#### APPEAL SUMMARY

<b>Appeal ID:</b> 25062	<b>Project Address:</b> 7000 NE Airport Way
<b>Hearing Date:</b> 8/11/21	<b>Appellant Name:</b> Tom Jaleski
<b>Case No.:</b> B-015	<b>Appellant Phone:</b> 971-238-5266
<b>Appeal Type:</b> Building	<b>Plans Examiner/Inspector:</b> David Bartley
<b>Project Type:</b> commercial	<b>Stories:</b> 1 <b>Occupancy:</b> A-3 <b>Construction Type:</b> I-A
<b>Building/Business Name:</b>	<b>Fire Sprinklers:</b> Yes - Throughout
<b>Appeal Involves:</b> Erection of a new structure	<b>LUR or Permit Application No.:</b>
<b>Plan Submitted Option:</b> pdf [File 1]	<b>Proposed use:</b> Airport

# PDXNext TCORE

### 3-Hour Fire Rating of Steel Beam

**Figure 1: Fireproofing of Steel Plate**

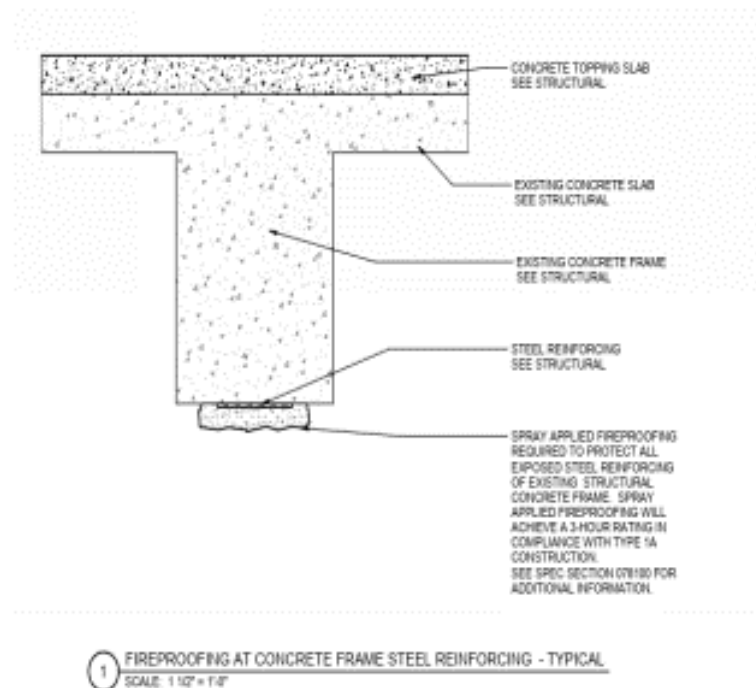
**Proposed Design** The proposed assemblies consist of large concrete members with reinforcing steel attached thereto. The steel in question is either C-channel or plate as shown in Figures 1 and 2 in the

The reinforcing steel assemblies are proposed to be protected with spray-applied fireproofing (see **Figures 1 and 2**). The assemblies are proposed to be protected in 3-hour fire-resistance rated construction in a manner utilizing components outlined UL Listed Design X854. The result of these efforts is an Engineering Judgment (EJ).

### **Alternate 3 hour fire rated C-channel and steel plate structural assemblies with engineering analysis: Granted as proposed.**
